CERTIFICATE OF APPROPRIATENESS

HPO File#: HP2026_0203

Property: 509 Sul Ross Street, BLK 2, single-family residential 2,687 sq. ft., in First Montrose Commons

Proposal: Alteration – Doors, Porch, Canopy, & Roof

NORTH FACADE - FACING SUL ROSS

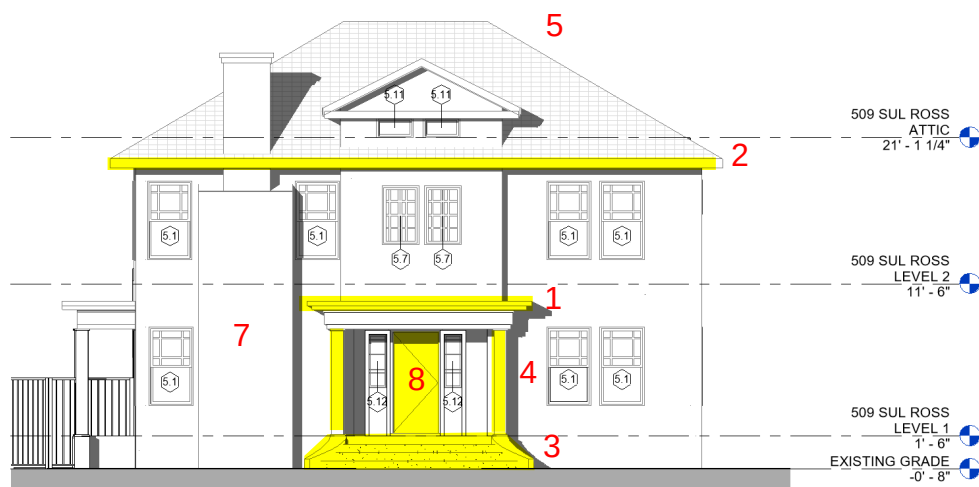
1. Replace existing modified bitumen front porch roof with a new 1:12 slope low profile standing seam metal roof. The current roof is causing water runoff at the windows, mold, mildew and holding water on the roof.

2. Around all sides of the house - Replace the rotting trim around the top of the wall below the soffit with 5/4 treated wood - painted to match the existing trim color. Replace the rotting wood fascia with 1x6 fiber cement flat trim board - painted to match trim color. Replace the rotting wood coved crown molding with new wood to match same profile. Replace the stucco soffit with a tongue and groove 1x4 to match original front porch soffit.

3. Demolish the front porch and re-pour new concrete to match existing shape and design. Replace front porch tile with new tile, same size and pattern. Add decorative metal handrails to the front steps for safety.

4. Replace missing front porch columns with round columns similar to the side porch.

5. Replace the existing shingled roof with new shingles, add gutters around the entire perimeter and add downspouts.

6. Restore all original windows and replace any broken glass. All decayed brick molding around windows to be replaced with new brick molding - match existing.

7. All stucco to be repaired matching existing texture.

8. Replace non-historic front door.

EAST FACADE

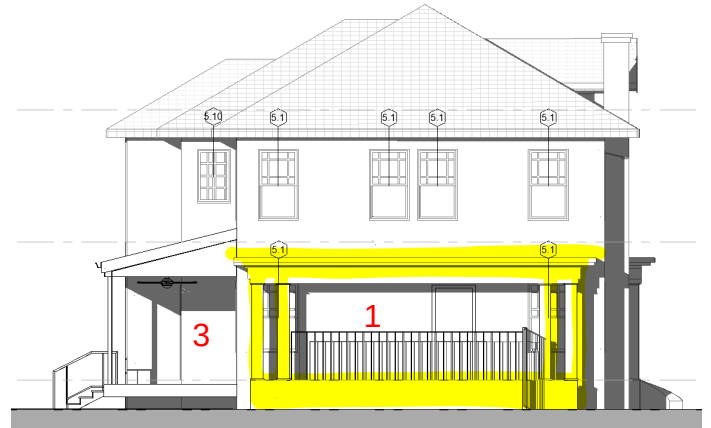
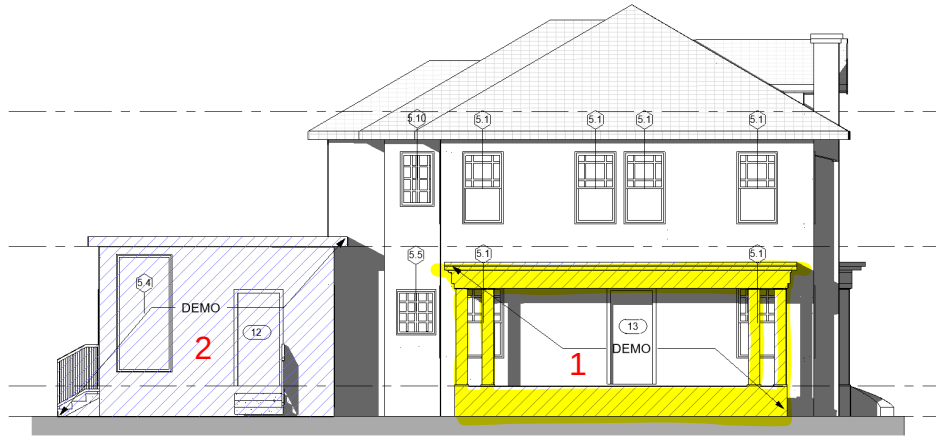
1. Rebuild side porch with new concrete landing and tile, new columns and new standing seam metal roof at 1:12 slope. The existing door will be removed and replaced a few feet to the right. A new guardrail and handrail will be installed along the perimeter and the steps.

2. A non contributing addition at the back will be removed.

3. A new back porch will be installed and will not be visible from the street.

NORTH ELEVATION EXISTING

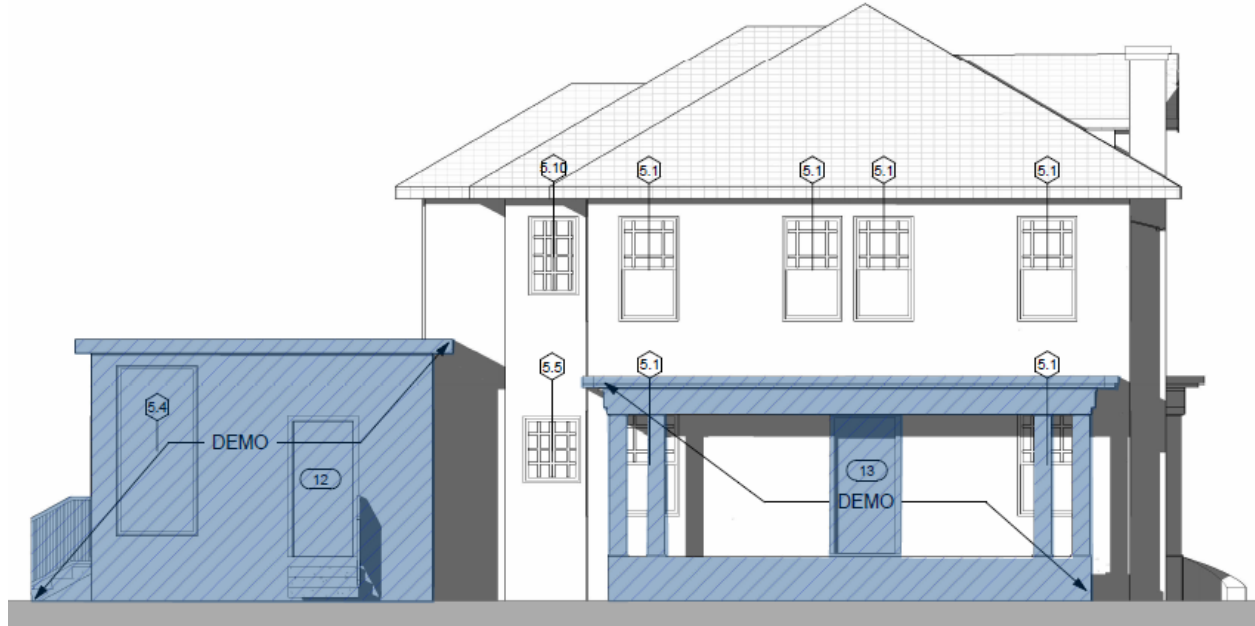
Rebuild concrete steps, new columns to match side porch, new door, new roof, refurbish rest.

REPLACE THE EXISTING SHINGLED ROOF WITH NEW SHINGLES. ADD GUTTERS AROUND ENTIRE PERIMETER WITH DOWNSPOUTS

REBUILD SIDE PORCH TO MATCH ORIGINAL WITH NEW 1:12 SLOPED METAL ROOF & METAL GUARDRAIL. STEPS TO FRONT WILL BE REMOVED

ON ALL SIDES REPLACE THE ROTTING TRIM AROUND DOORS & WINDOWS WITH TREATED WOOD, SAME PROFILE. REPLACE FASCIA WITH FLAT 1X6 FIBER CEMENT. REPLACE COVED CROWN TRIM WITH SAME PROFILE TREATED WOOD. REPLACE STUCCO SOFFIT WITH NEW TONGUE & GROOVE BOARD.

REPLACE EXISTING ROOF ON FRONT PORCH WITH 1:12 STANDING SEAM METAL ROOF AND FLASHING AROUND THE FASCIA. REPLACE NON-HISTORIC FRONT DOOR.

DEMO AND REPOUR THE FRONT PORCH TO MATCH ORIGINAL. REPLACE TILE IN ENTRY WAY. REPLACE MISSING FRONT PORCH COLUMNS WITH NEW ROUND COLUMNS TO MATCH THE SIDE PORCH.

ALL HISTORIC WINDOWS TO REMAIN. STUCCO WILL BE REPAIRED MATCHING EXISTING TEXTURE.

Addition of wrought iron handrails and new door.

EAST ELEVATION EXISTING (Proposed Removal of Door, Demo Rear Addition)

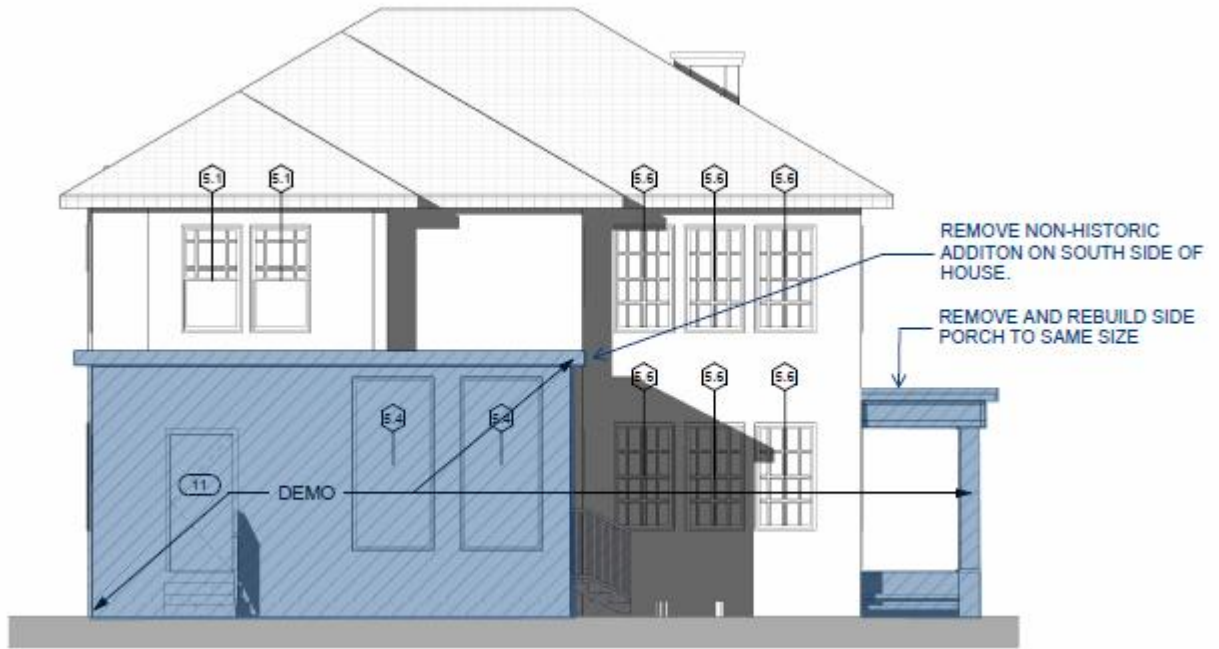
New door, to right of existing, addition of wrought iron handrails.

Historic Window Standard: New Construction & Replacement

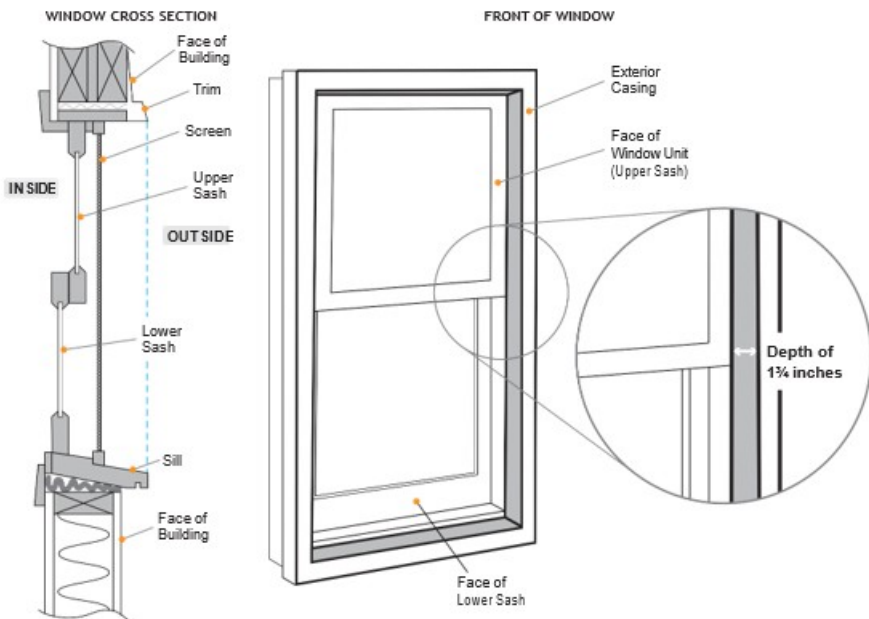
ALL RESTORED & ANY NEW WINDOWS are to be **Inset and Recessed**.

Minimum 1 3/4 inch Inset

- Depth from Exterior Casing to the Face of the Window Unit (Upper Sash)
- Windows must be 1-over-1 (equally horizontally divided)
- 1 3/4 inch minimum inset for Fixed Window
